SERVICE BULLETIN

Bulletin No. : 02-C/M-E0061

Model : GH15 LCD monitor.

SUBJECT : SIDE GASKET POSITION CHANGE.

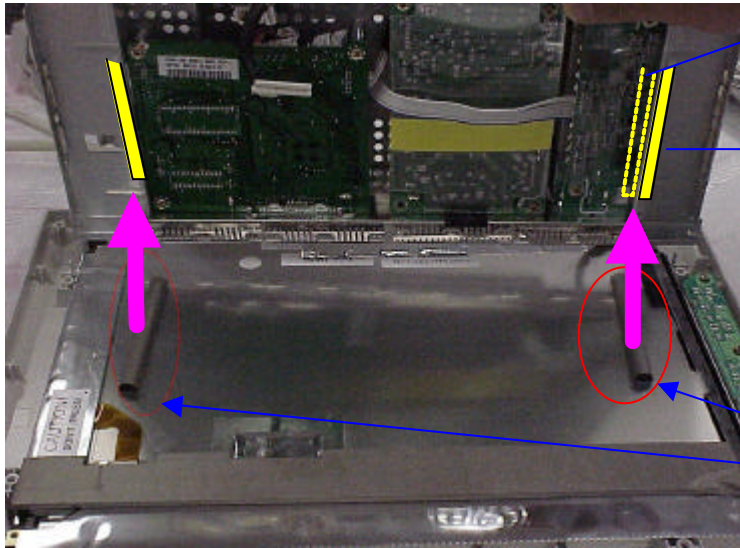
Background : There are 2 side gasket in GH15 LCD model which connecting LCD panel body and metal shield for EMI(Electro-Magnetic Interference) countermeasure.

If this gasket attached wrongly, it may touch with main PCB and cause some problem.

such as OSD broken or Full white display, No raster, menu function does not operate etc...

Samsung changed gasket attaching point from LCD panel to metal braket to prevent this problem.

Poor position
Touch with PBA => Cause Problem

Original Contact point

Solution Open back cover and remove cables and metal braket.

and check gasket position, if gasket touch with main board then, remove 2 gaskets and attach on metal braket. Check again wheter symptom disappeared.
